Well Name: JAMES RANCH UNIT DI 7 SAWTOOTH	Well Location: T23S / R31E / SEC 6 / LOT 1 /	County or Parish/State:
Well Number: 804H	Type of Well: OIL WELL	Allottee or Tribe Name:
Lease Number: NMNM02887B	Unit or CA Name: JAMES RANCH UNIT	Unit or CA Number: NMNM70965X
US Well Number: 3001554885	Well Status: Approved Application for Permit to Drill	Operator: XTO PERMIAN OPERATING LLC

Sundry ID: 2779264

Type of Submission: Notice of Intent	Type of Action: APD Change
Date Sundry Submitted: 03/12/2024	Time Sundry Submitted: 11:31
Date proposed operation will begin: 04/01/2024

Procedure Description: XTO Permian Operating, LLC. respectfully requests approval to make changes to the approved APD (10400093035) as follows: SHL, FTP, LTP, BHL and proposed TD/TVD. Formation will stay as Bone Spring. FROM: TO: SHL: 155' FNL & 320' FEL OF SECTION 6-T23S-R31E 155' FNL & 410' FEL OF SECTION 6-T23S-R31E FTP: 330' FNL & 2090' FWL OF SECTION 5-T23S-R31E 330' FNL & 1590' FWL OF SECTION 5-T23S-R31E PPP: 1318' FNL & 2089' FWL OF SECTION 5-T23S-R31E 1319' FNL & 1589' FWL OF SECTION 5-T23S-R31E LTP: 2540' FNL & 2090' FWL OF SECTION 17-T23S-R31E 2540' FNL & 1590' FWL OF SECTION 17-T23S-R31E BHL: 2590' FNL &

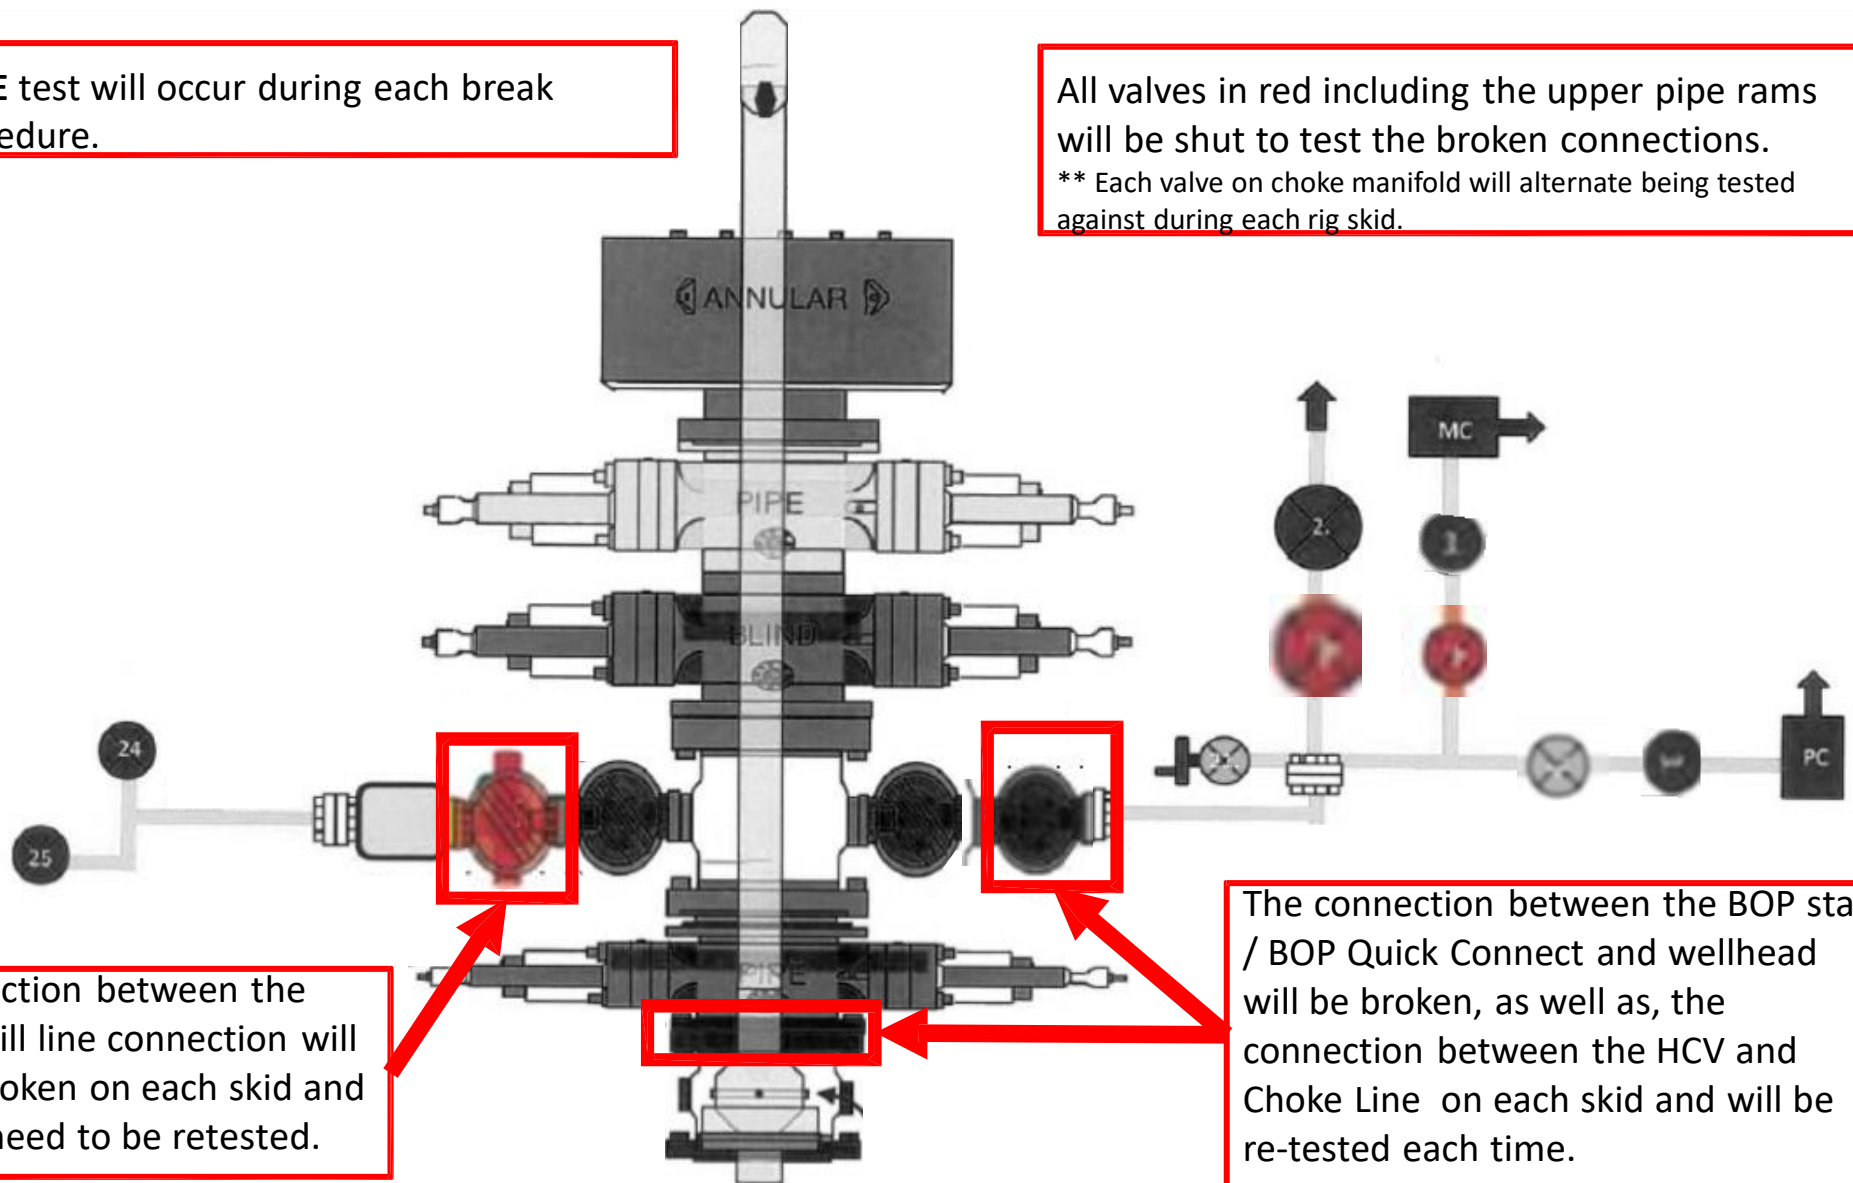
All valves in red including the upper pipe rams will be shut to test the broken connections.
** Each valve on choke manifold will alternate being tested against during each rig skid.

The connection between the HCV and kill line connection will **NOT** be broken on each skid and does not need to be retested.

Form C-102
Revised August 1, 2011
Submit one copy to appropriate
District Office

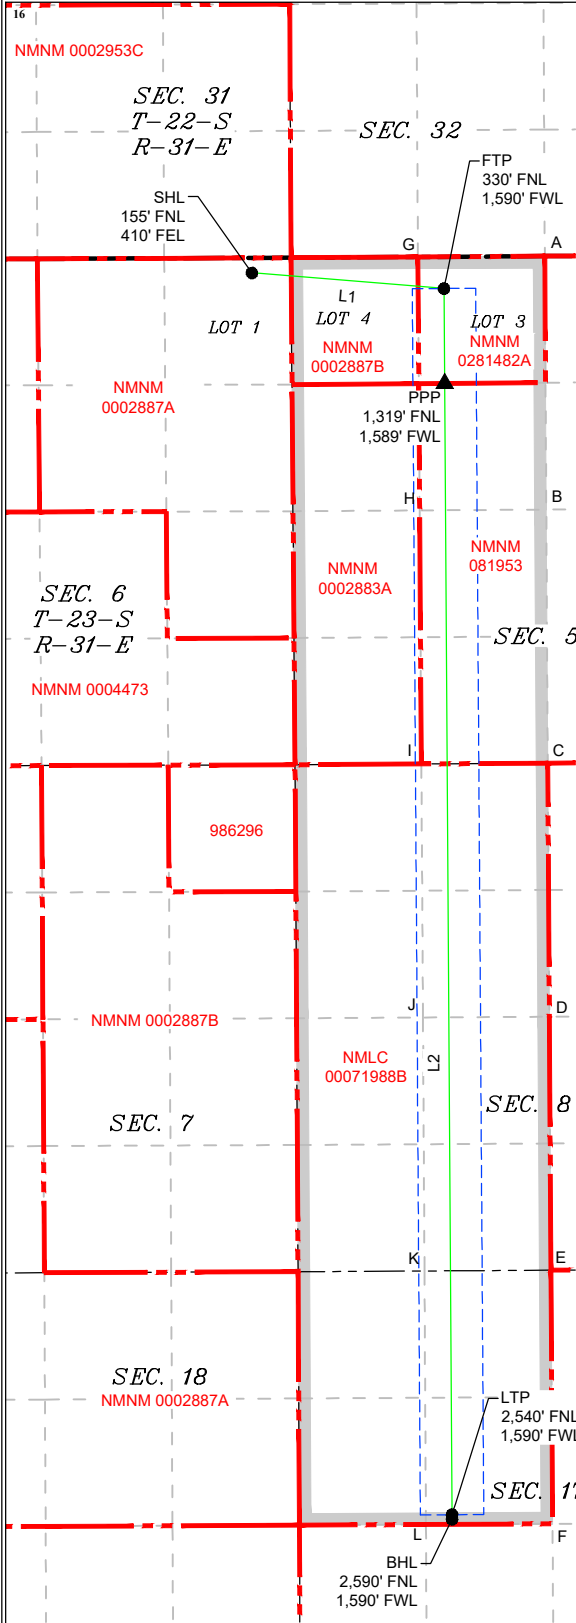
Total depth will be changing from 24001 MD; 10502 TVD (Bone Spring) to 22861 MD; 9905 TVD (Bone Spring).

0. SHL: LOT 1 / 155 FNL / 320 FEL / TWSP: 23S / RANGE: 31E / SECTION: 6 / LAT: 32.340325 / LONG: -103.809493 (TVD: 0 feet, MD: 0 feet)

PPP: LOT 4 / 178 FNL / 0 FWL / TWSP: 23S / RANGE: 31E / SECTION: 5 / LAT: 32.340262 / LONG: -103.808458 (TVD: 2831 feet, MD: 2843 feet)

PPP: LOT 3 / 330 FNL / 2090 FWL / TWSP: 23S / RANGE: 31E / SECTION: 5 / LAT: 32.339852 / LONG: -103.801689 (TVD: 10502 feet, MD: 11181 feet)

PPP: SENW / 1318 FNL / 2089 FWL / TWSP: 23S / RANGE: 31E / SECTION: 5 / LAT: 32.337135 / LONG: -103.801684 (TVD: 10502 feet, MD: 12501 feet)

BHL: SENW / 2540 FNL / 2090 FWL / TWSP: 23S / RANGE: 31E / SECTION: 17 / LAT: 32.304611 / LONG: -103.801623 (TVD: 10502 feet, MD: 24001 feet)

¹¹ Bottom Hole Location If Different From Surface									
UL or lot no.	Section	Township	Range	Lot Idn	Feet from the	North/South line	Feet from the	East/West line	County
F	17	23 S	31 E		2,590	NORTH	1,590	WEST	EDDY

LINE TABLE		
LINE	AZUMITH	LENGTH
L1	274°39'55"	2,007.52'
L2	179°37'25"	12,820.10'
